SERVICE BULLETIN

Classification: EL18-038	Reference: NTB18-085	Date: December 13, 2018
-----------------------------	-------------------------	----------------------------

2018 TITAN CREW CAB AND TITAN XD CREW CAB; RUNNING BOARD LIGHT COVERED

Figure 1

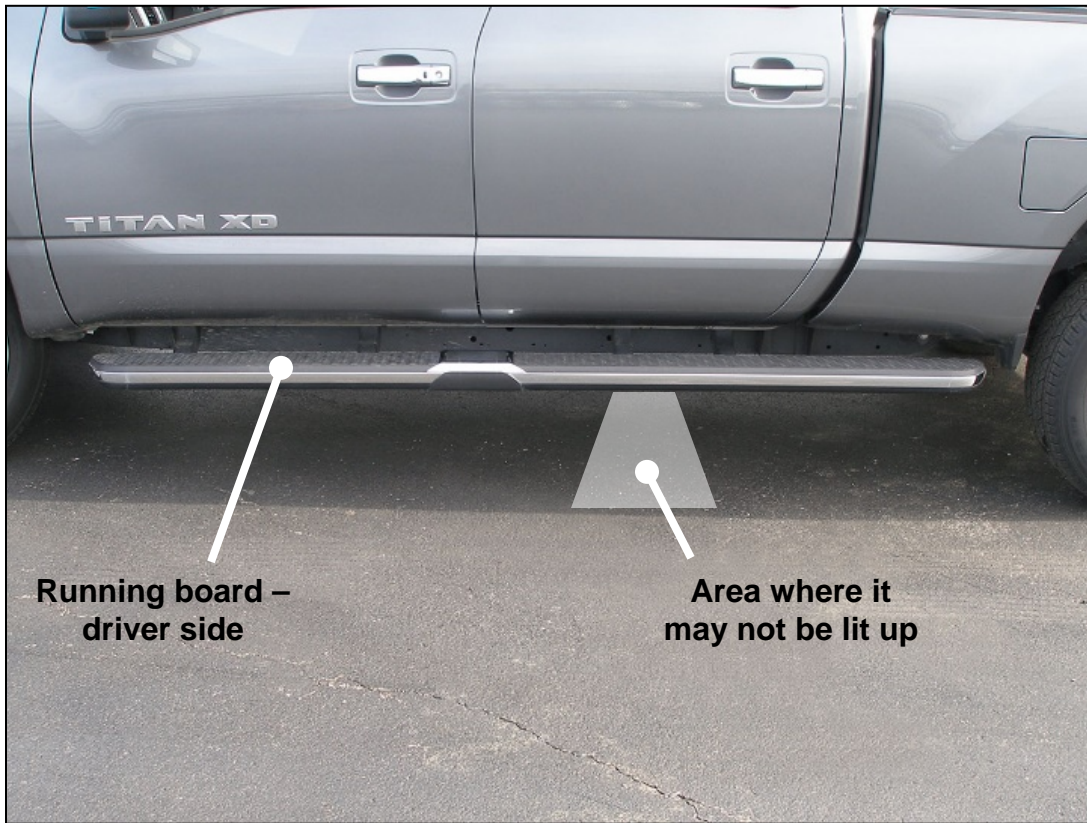
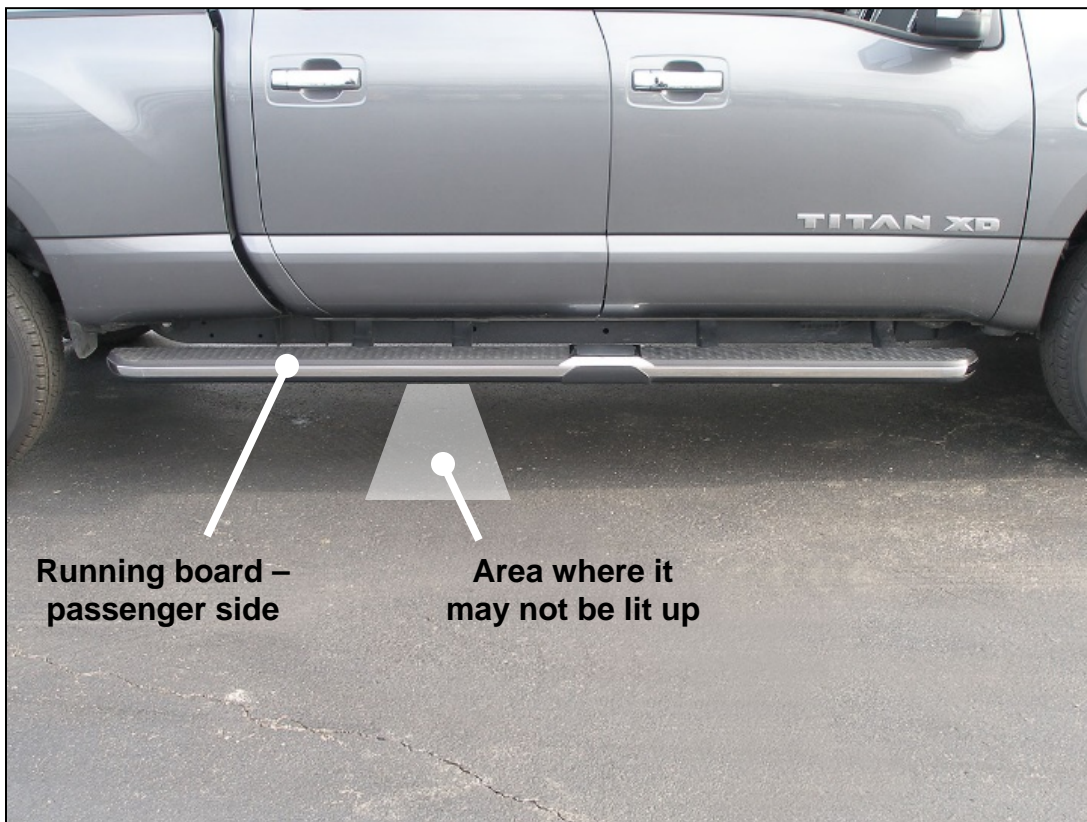
The running board light near the middle of one or both running boards does not appear to light up (see Figures 1 and 2 on the next page)

The hole in the running board's reinforcement bracket does not line up with the running board light (the light is covered).

Replace the running board on the side of the vehicle where the running board light does not appear to be lit up.
